## **Access Compliance Report Public Rights-of-Way** (Island Curb Cuts)

Intersection ID: 3559 Main Street: PERIMETER PY Cross Street: W W T HARRIS BV SE Location: ADA ID: A8675153EDC9 Severity Score: 36.25

Curb Cut Type: IslandRefuge3 Initial Pass/Fail: Fail **Overall Compliance: No**

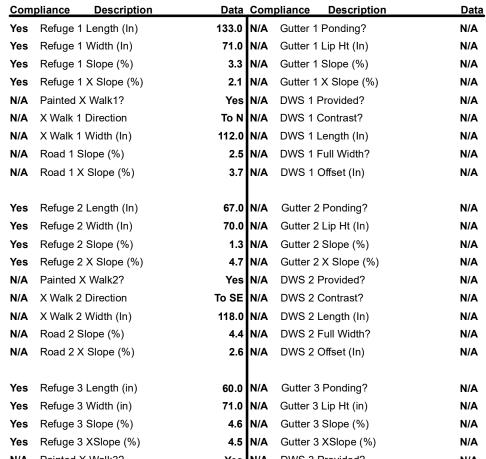
res	Refuge 3 Width (in)	/1.0 N/	Α	Gutter 3 Lip Ht (in)	N/A
Yes	Refuge 3 Slope (%)	4.6 N/	Α	Gutter 3 Slope (%)	N/A
Yes	Refuge 3 XSlope (%)	4.5 N/	Α	Gutter 3 XSlope (%)	N/A
N/A	Painted X Walk3?	Yes N/	Α	DWS 3 Provided?	N/A
N/A	X Walk 3 Direction	To W N/	Α	DWS 3 Contrast?	N/A
N/A	X Walk 3 Width (in)	108.0 N/	Α	DWS 3 Length (in)	N/A
N/A	Road 3 Slope (%)	3.4 N/	Α	DWS 3 Full Width?	N/A
N/A	Road 3 XSlope (%)	4.6 N/	Α	DWS 3 Offset (in)	N/A
Yes	Any Obstructions?	N/A N/	Α	Storm Grate/Utility Hazard?	N/A
N/A	Obstruction Type	N/	Α	Storm Grate/Utility Type	
		N/A			N/A
N/A	Surface Condition	Good

Remove & Replace Entire Refuge.
